UNITED STATES PATENT AND TRADEMARK OFFICE

10/580,168

Office Action Summary	Application No. 10/580,168	Applicant(s) LINDNER ET AL.	
	Examiner STEPHANIE JENNINGS	Art Unit 4135

DETAILED ACTION

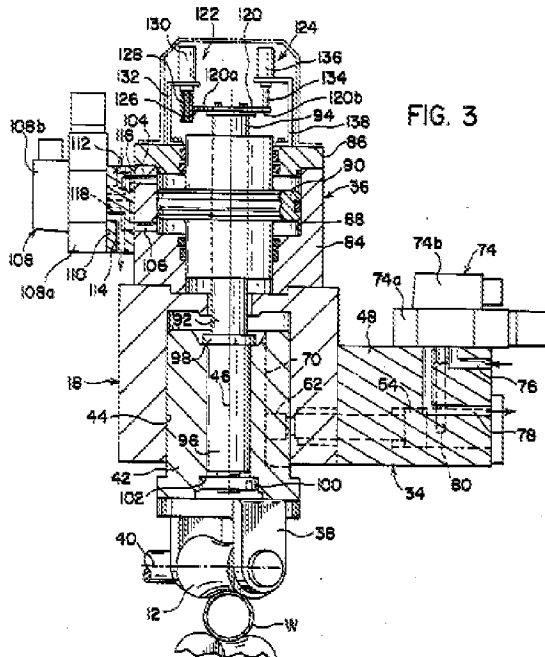
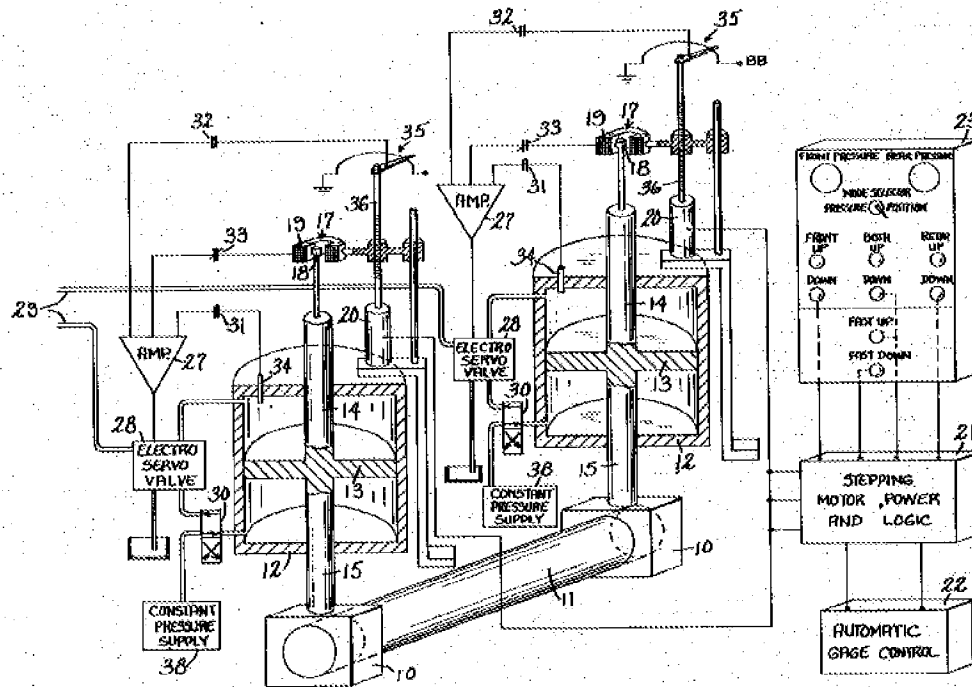
12. Limitations from claim 1, adjusting cylinder for long, rapid lifting movements in rolling stands, including vertical edging stands, wherein each cylinder has at least one piston (54, 56),

wherein each adjusting cylinder has a piston (54, 56) that is equipped with two oppositely directed piston rods (50, 52) which acts by means of the bearing chocks of at least one work roll or of an interposed roll to adjust a work roll on both sides and each piston is inserted in a recess in the cylinder base (42), such that said base and cover have coaxially arranged bores (44) through which the piston rods (50, 52) pass, wherein the surface (70) formed by the piston (54) and the piston rod (50) is smaller than the surface (72) formed by the piston (56) and the piston rod (52) (column 6, lines 12-40).

Fig 1

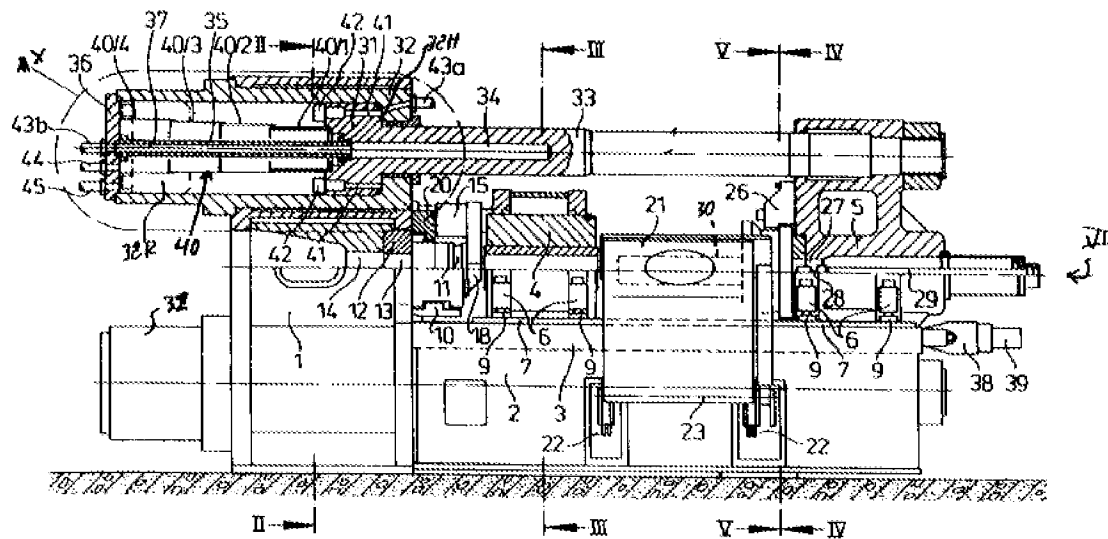
28. Limitations from claim 3, adjusting cylinder in accordance with claim 1, wherein seals that belong to the cylinder (32) are located in the cover (32R, H) and in the piston (31) (column 2, lines 38-45, column 4, lines 8-17 and 29-46).

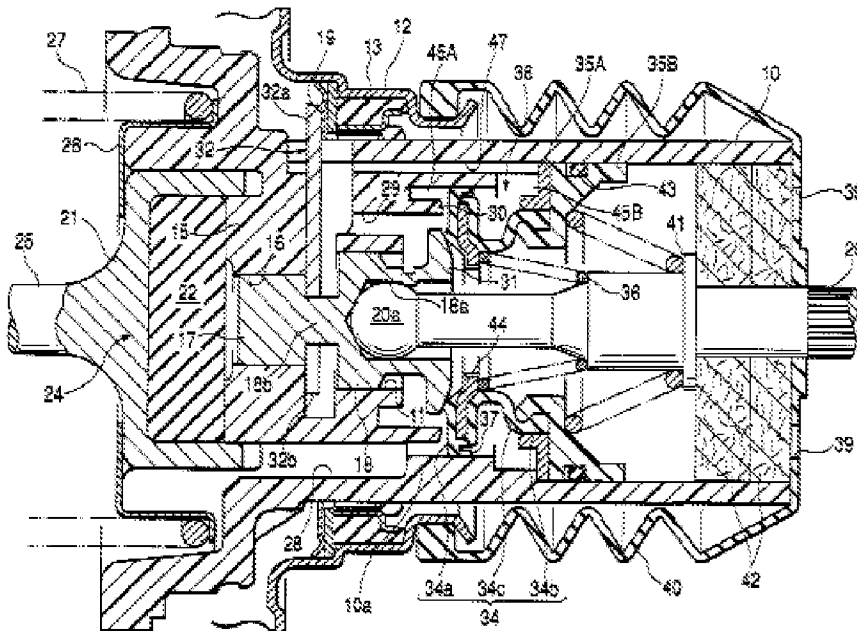
33. Limitations from claim 9, adjusting cylinder in accordance with claim 1, wherein the piston (translated abstract, paragraph 2, line 2) has an antitorsion device (translated abstract, paragraph 1, line 1)
